PROJECT #1147

1925 EL CAMINO DE LA LUZ
SANTA BARBARA, CA 93109

1925 EL CAMINO DE LA LUZ RESIDENCE (MST#2013-00240)
MITIGATION MONITORING AND REPORTING PROGRAM

June 22, 2016

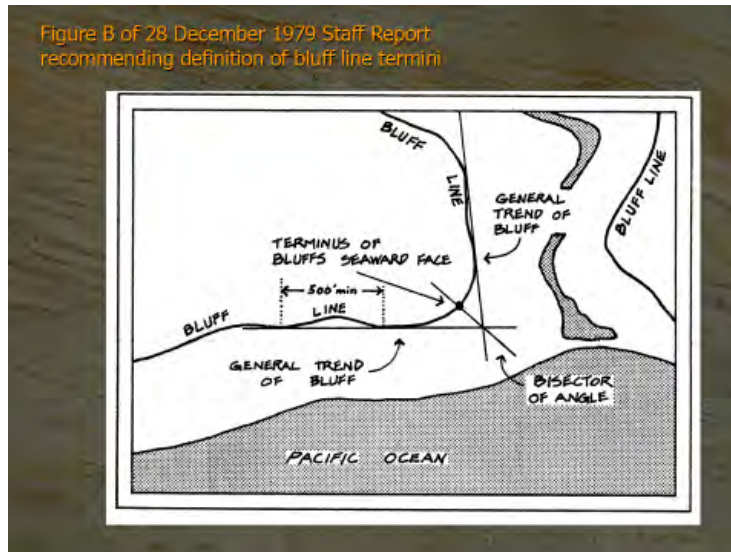
(2) 500 foot distance criterion. The comments assert that the 51 foot elevation for bluff edge would meet the CCR Title 14 §13577 regulation for determining bluff edge, including that the bluff edge distance would meet and exceed the 500-foot criterion, while the landslide headscarp at 127 foot elevation identified by staff would not meet the 500-foot distance criteria of the CCR bluff edge regulation for identifying a bluff edge and cannot be determined to be the bluff edge.

Response: Coastal Commission staff communication to City staff (*Megan Sinkula, Coastal Program Analyst, 04-20-16, 05-02-16 emails*) confirmed that the 500 foot criterion in CCR 13577 refers to the minimum area to be examined in making a coastal bluff determination, and not the minimum length of a coastal bluff or bluff edge, and that the criterion is used only in distinguishing between the coastal bluff and canyon bluffs. MND Exhibit F4 indicates the 500 foot area considered.
